MFN 08-718

Docket No. 52-010

**Subject: Response to Portion of NRC Request for Additional  
Information Letter No. 224 Related to ESBWR Design  
Certification Application - Containment Systems -  
RAI Numbers 6.2-182, 6.2-183, 6.2-187, and 6.2-190**

**Response to Portion of NRC Request for  
Additional Information Letter No. 224  
Related to ESBWR Design Certification Application**

**Figure 6.2-190-1. Containment Drywell, Wetwell, and Reactor Pressure Vessel Pressures With and Without PCCS Vent Fans**

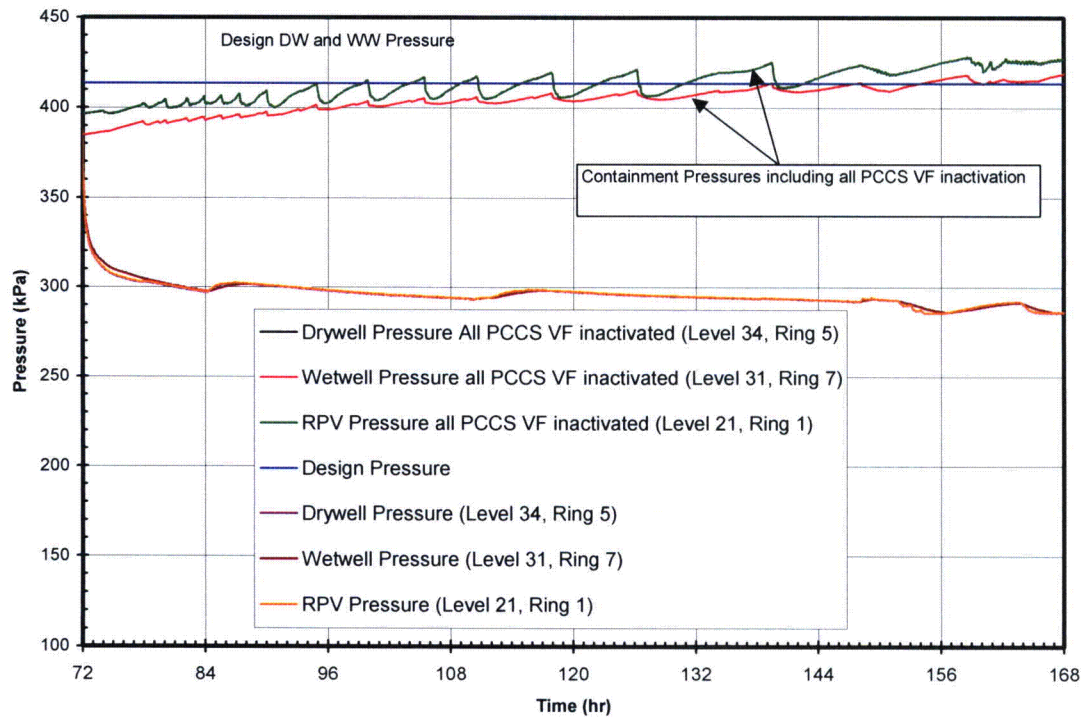
*ESBWR DCD Revision 5 Section 6.2.2.2.2 states that vent fan is teed off of each PCCS vent line and that vent is powered by reliable sources. However, the DCD provides no design details, appropriate analysis or references. Please, revise the DCD to include the following or to provide appropriate references:*

- A. Design details of the added vent fan system, in particular the required characteristics of the fans, i.e., flow versus delta-P data.*
- B. Details of the system behavior, in particular a comparison of the containment pressure transients with and without fans active.*
- C. A minimum requirement for vent fans performance, i.e., the minimum number of fans operating to achieve the desired effect.*
- D. A discussion of potential adverse effects of the modification, if any, including effects of fans failure.*

- B. Details for the PCCS behavior due to the PCCS vent fan system are discussed in the response to RAI 6.2-139 (MFN 08-357) and DCD Tier 2, Revision 5. DCD Tier 2 Revision 5 changes as described in the response to RAI 6.2-139 reflect the PCCS vent fan system design, including DCD Tier 2, Subsection 6.2.2.2.2 and Figures 6.2-14e1 through 6.2-14e10. The comparisons of the containment pressure and temperature responses with and without PCCS vent fans operating were not provided in DCD Tier 2, Revision 5. However, these comparisons are provided in this response as requested in Figures 6.2-190-1 and 6.2-190-2.

- D. The only expected adverse impact is due to the failure of all PCCS vent fans during the event (72 to 168 hours following a LOCA). Failure of all PCCS vent fans results in a small and continuous increase of the containment pressures and temperatures. The increase average value for the drywell (DW) pressure at the end of 168 hours is small; and ends up only slightly above design pressure. The average DW pressure slowly increases about 30.70 kPa (4.45 psi) above the initial pressure of 396.25 kPa, or about 15.63 kPa (2.27 psi) above design pressure. The wetwell (WW) pressure also has a similar increase, increasing about 34.09 kPa (4.94 psi) above the 384.84 kPa initial value (See Figure 6.2-190-1).
